AM 100% mod (1kHz)
1 mHz
-20dbm (10μw)

PH MARCH 2016

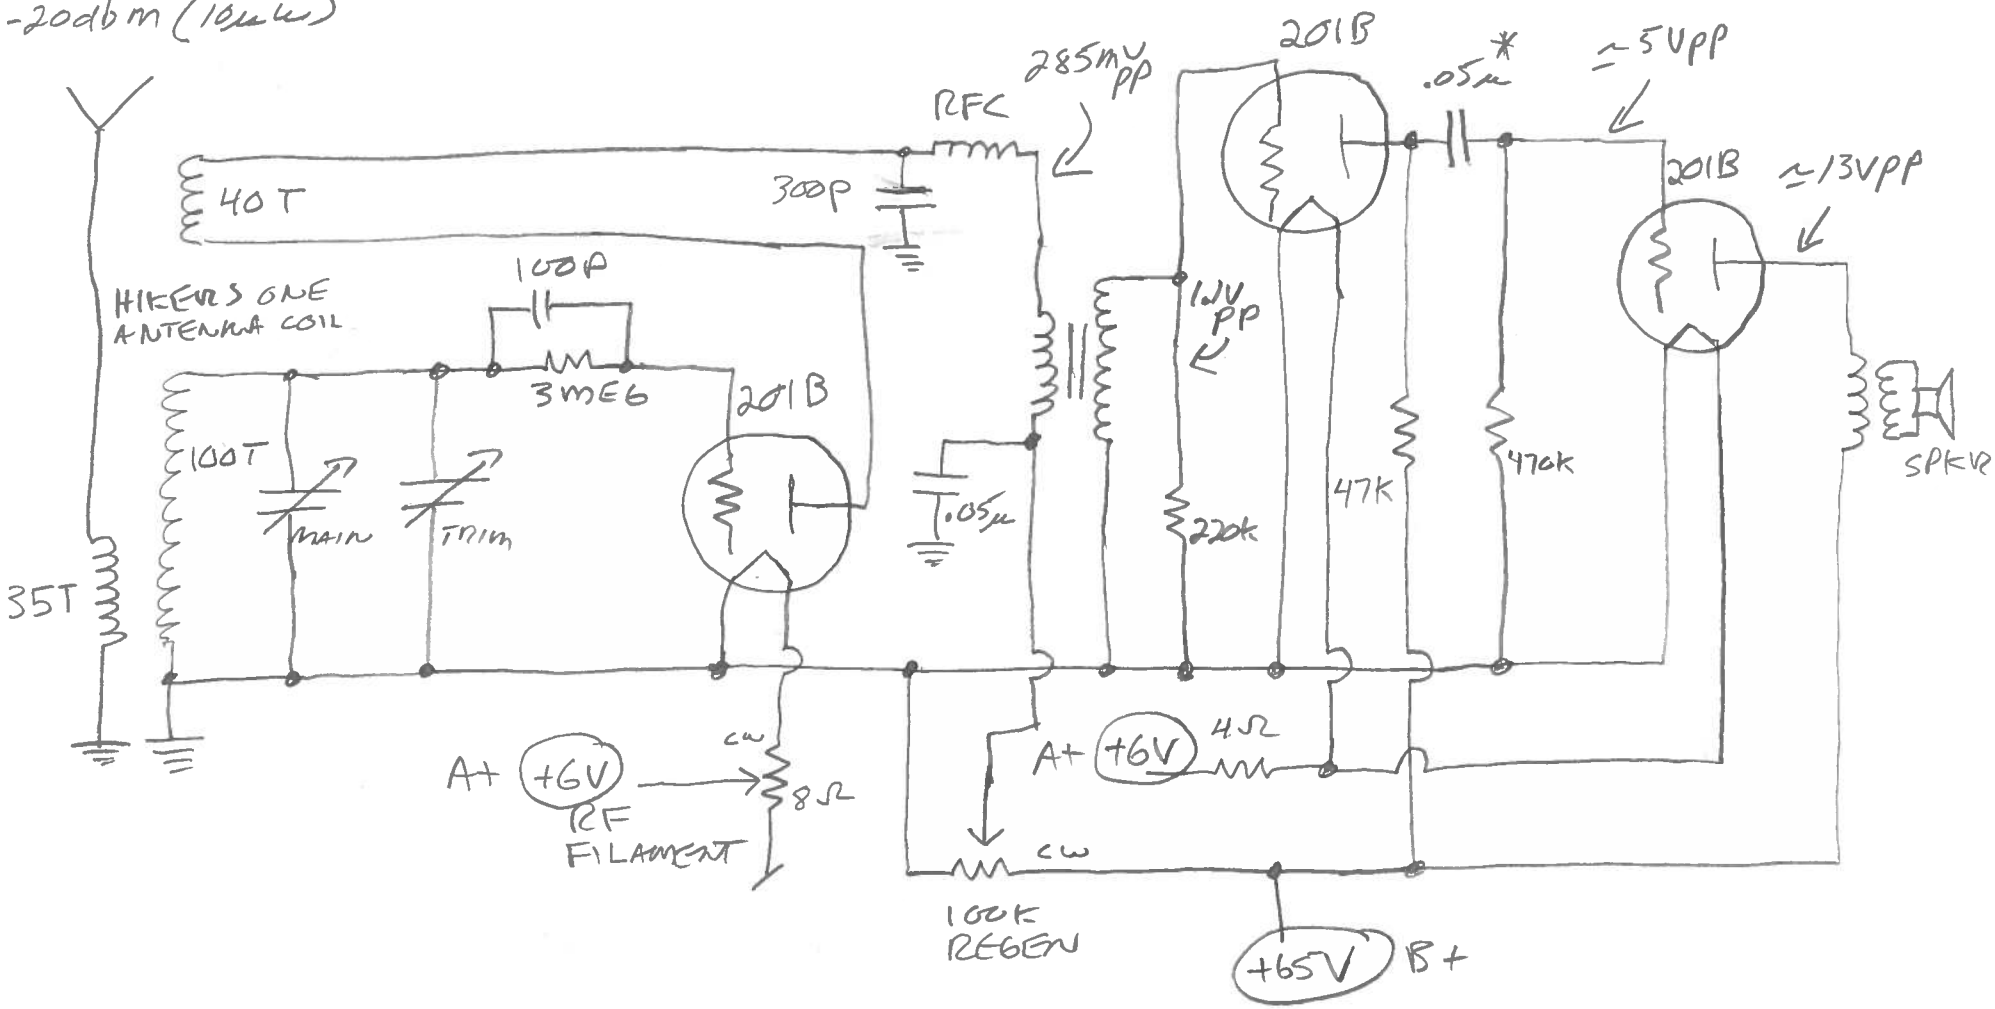
* .05μ TO BE REPLACED BY 500 SET TRANSFORMER FOR APPROX 6 TO 8 db MORE GAIN... (TBD.)
